Comhairle Contae Chorcaí Cork County Council

Request for a technical amendment to licence register number D0202-01 agglomeration of Mitchelstown

Cork County Council request a technical amendment of licence register number D0202-01 under Section 33(1) of the wastewater discharge authorisation regulations S.I. 684 of 2007.

Attached – Map E2 and revised Table E3

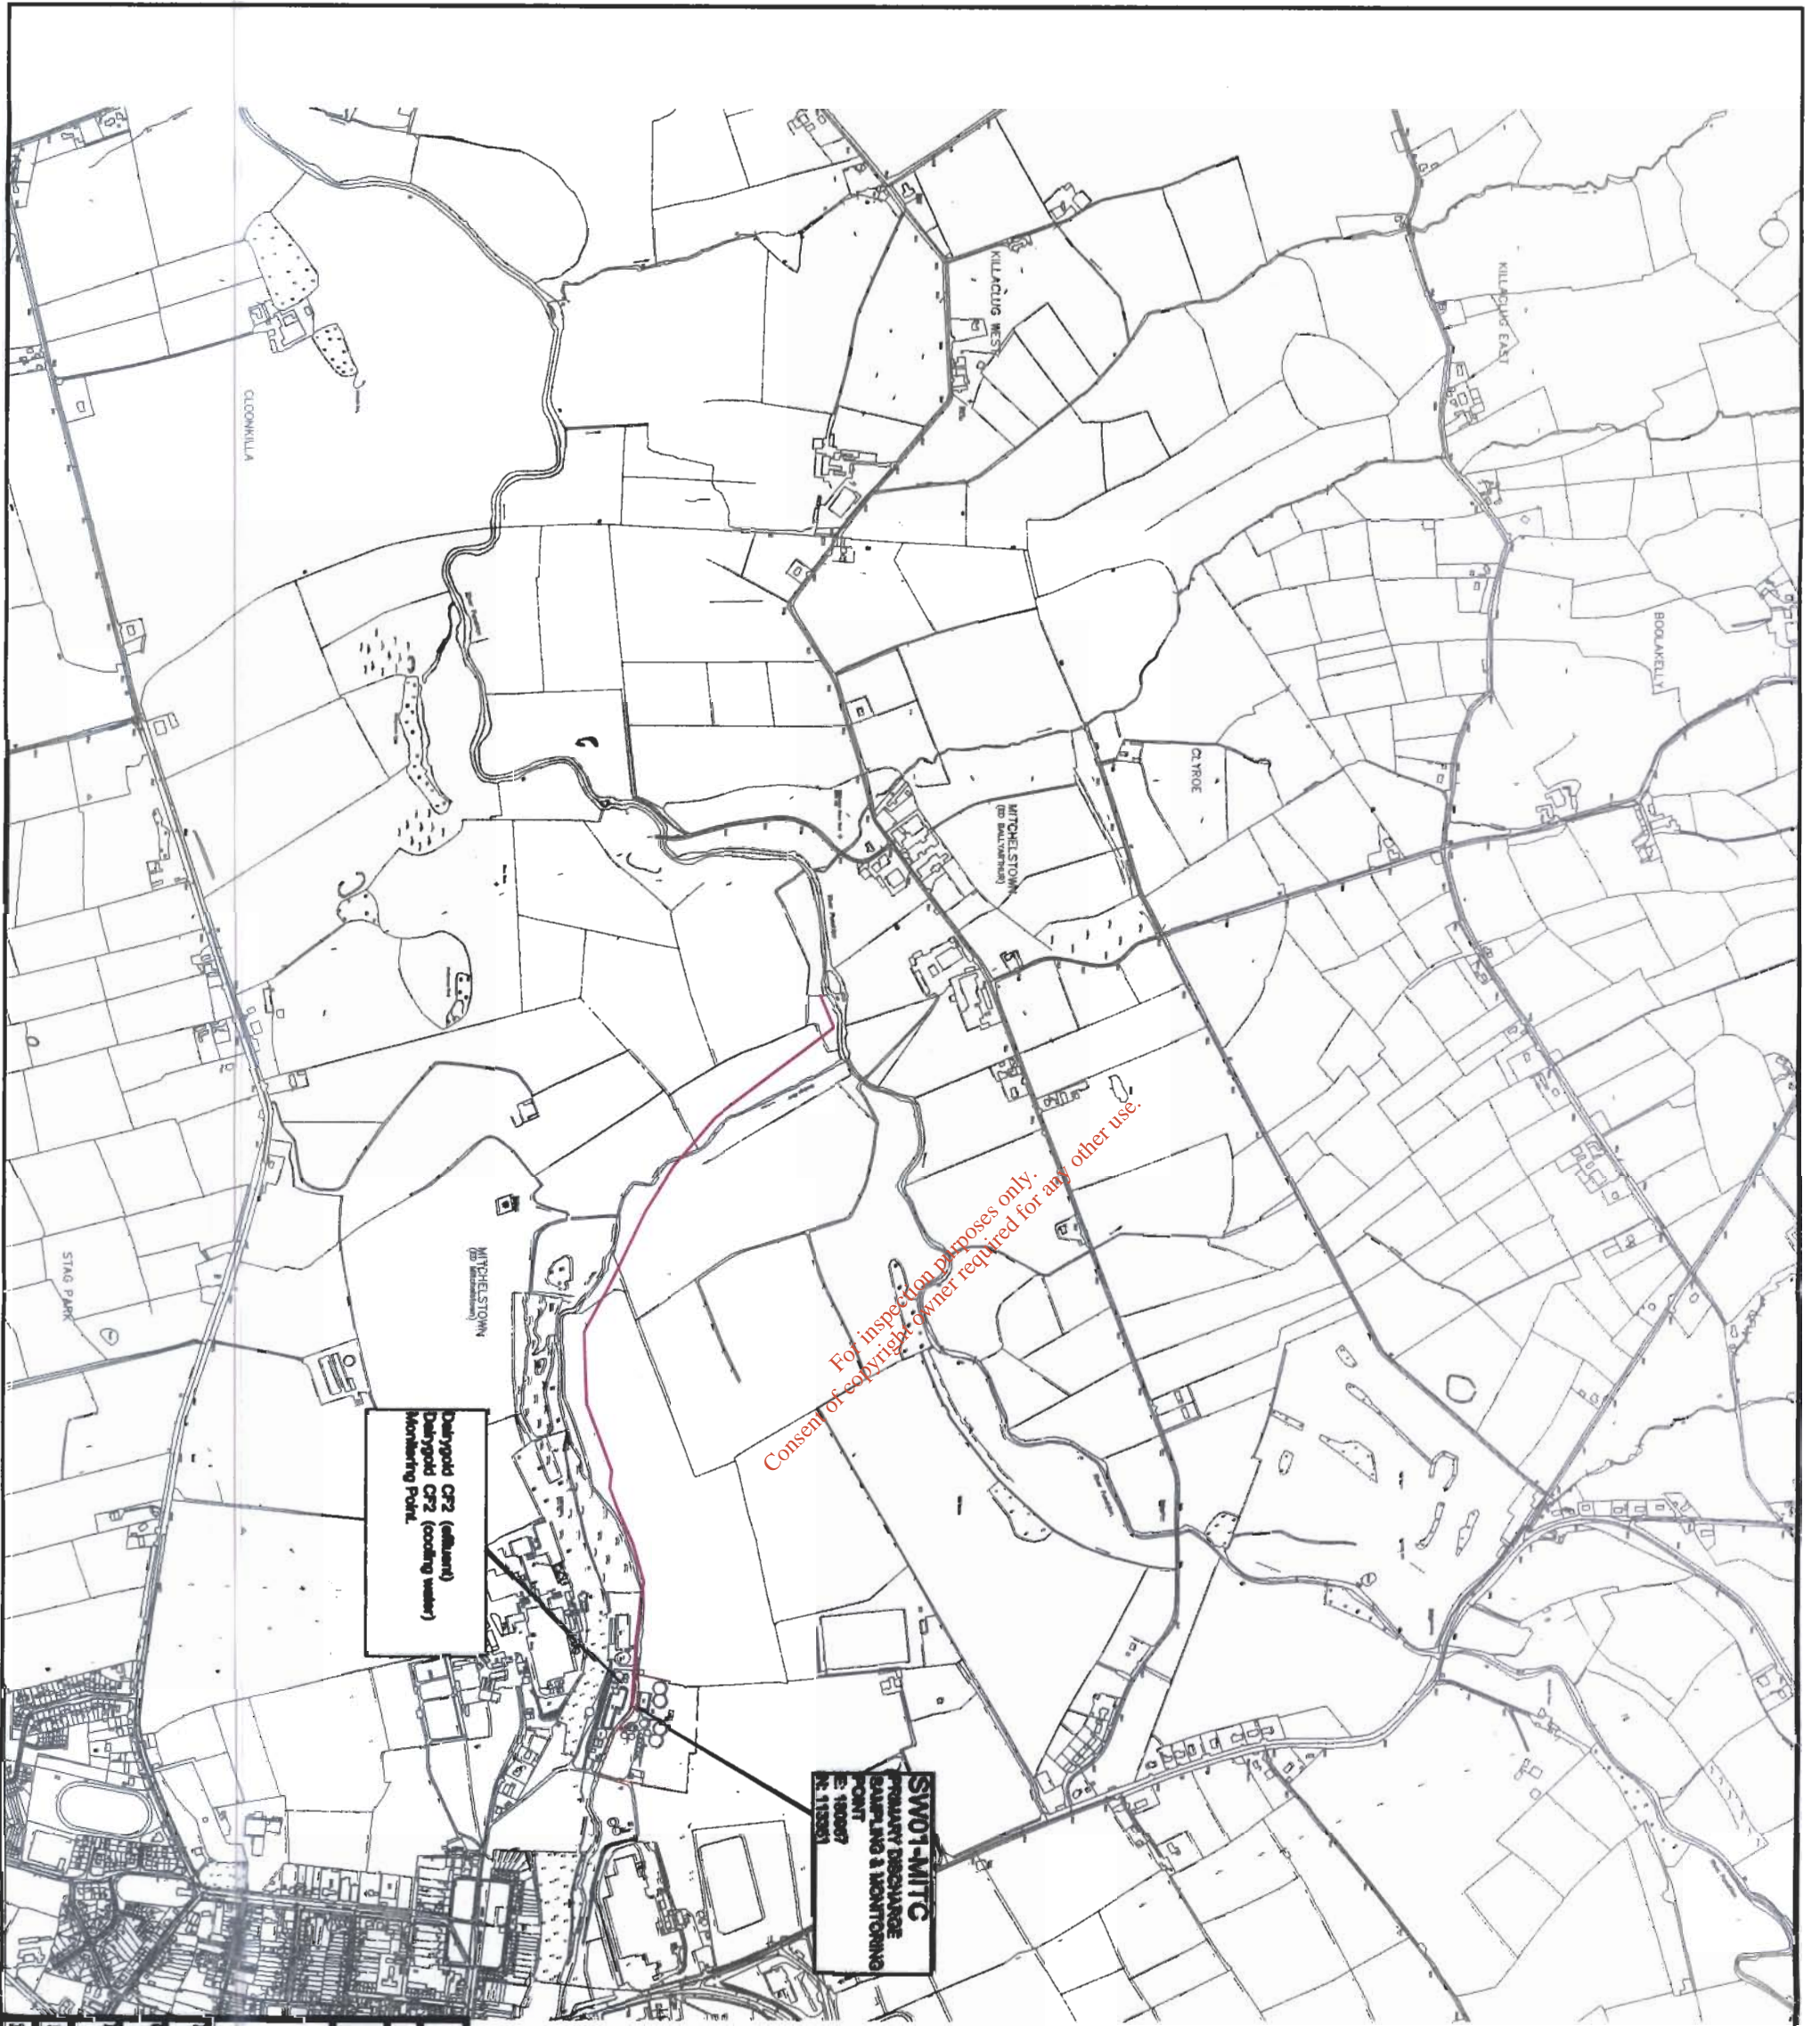
a. Condition 4.3, Schedule 2.1 & Schedule B.1 - the monitoring location to be defined as a sample prepared from a flow proportional and flow related composite sample that is prepared from samples collected from both the Mitchelstown Wastewater Treatment Plant and the IPPC facility Dairygold Co-Op Society Ltd. Register number P0404-02. This sample will be prepared on a flow ratio basis by combining the sample on a ratio using the known flows on the day of sampling. A copy of revised map E2 is submitted with this request and a revised table E3.

Rationale for request – the final discharge manhole for the combined discharge from both facilities is located in land that is privately owned by a third party. Both pipes travel separately to this location and do not combine until this manhole. This location does not have a source of electrical power and Cork County Council is unable to install electrical supplies as this land is privately owned. Furthermore it is not possible to install temporary portable equipment at this location as there are health and safety issues that relate to access for staff in both the agency and the local authorities.
